V2500-A1/A5/D5 SERIES PROPULSION SYSTEMS SERVICE BULLETIN

This document transmits Revision 1 to Service Bulletin EV2500-72-0478 and Revision 1 to the Supplement

V2500-ENG-72-0478

ENGINE – REPLACE NUMBER 3 BEARING CARBON SEAL ASSEMBLY

ENGINE - NUMBER 3 BEARING REAR OIL SEAL
Figure 1

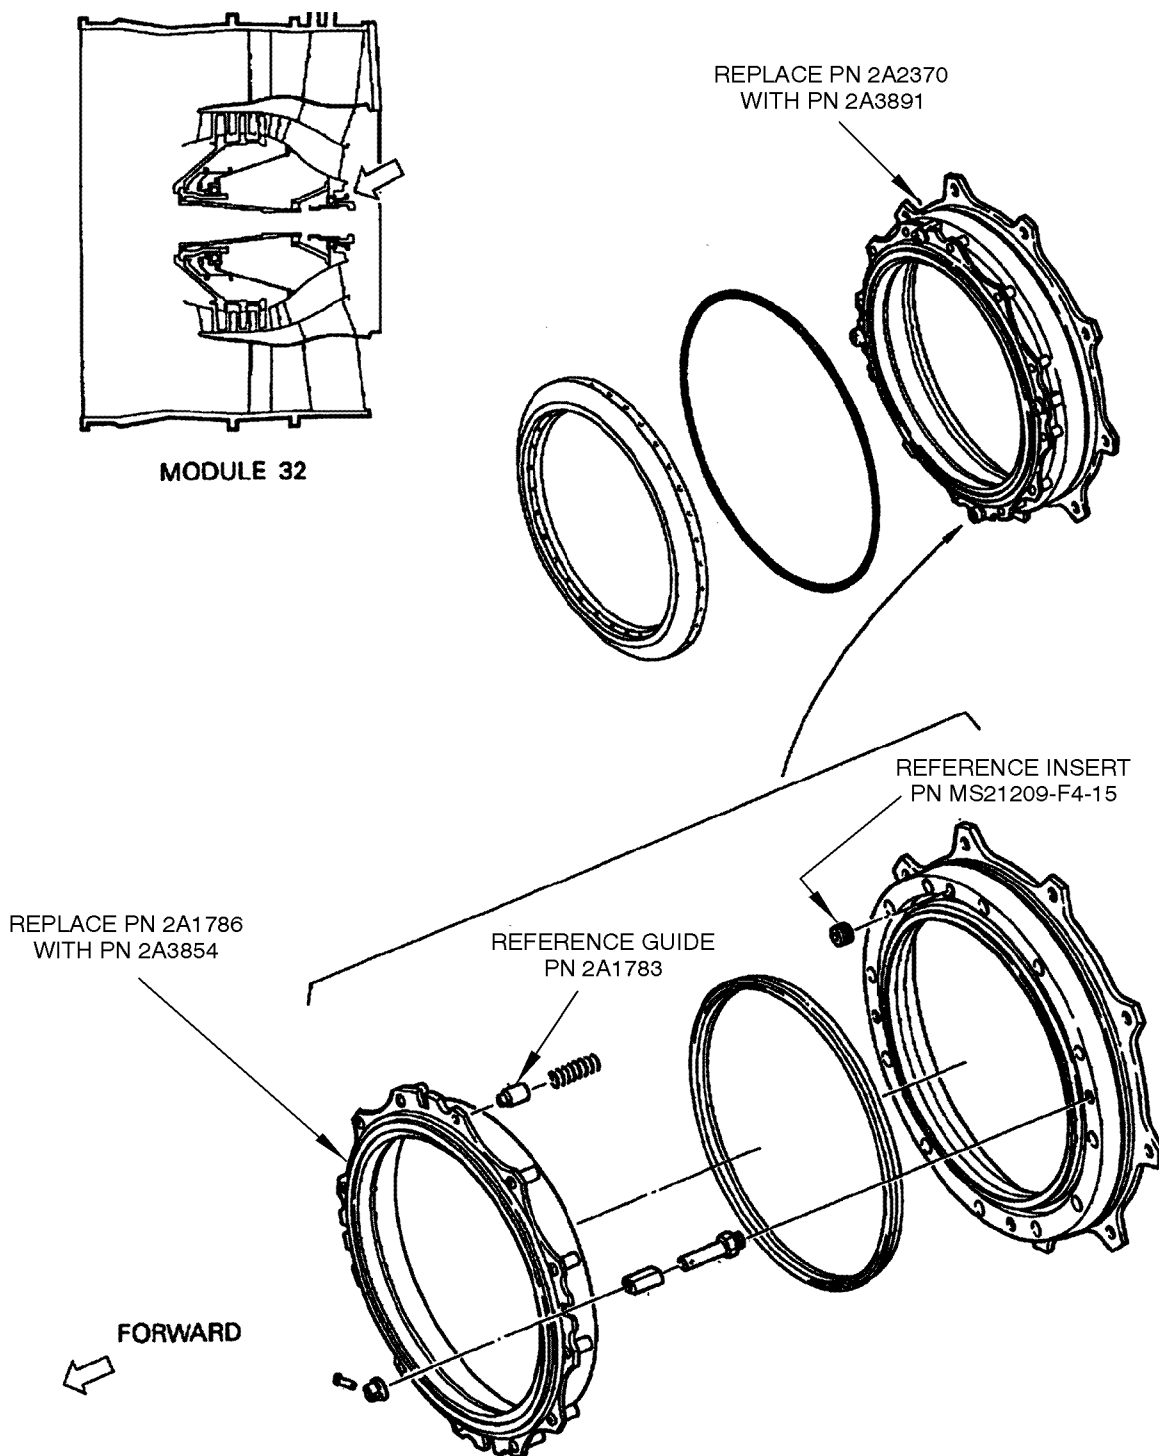
(1) Modification of Seal Assembly and Seal Face Assembly

(a) Remove the number 3 bearing seal assembly from the front bearing compartment per:

(b) Disassemble the number 3 bearing seal assembly per Engine Manual Task 72-32-25-040-001 Subtask 72-32-25-040-051 (All Models).

R (c) Send the number 3 bearing Seal Face Assembly PN 2A1786 to one of the
R authorized repair facilities referenced in 72-32-25-300-007 (VRS3393)
R for carbon seal detail replacement.

(3) Assemble the number 3 bearing seal assembly per Engine Manual Task 72-32-25-440-001 (All Models).

(4) Identify the reoperated part per the Reidentified Section.
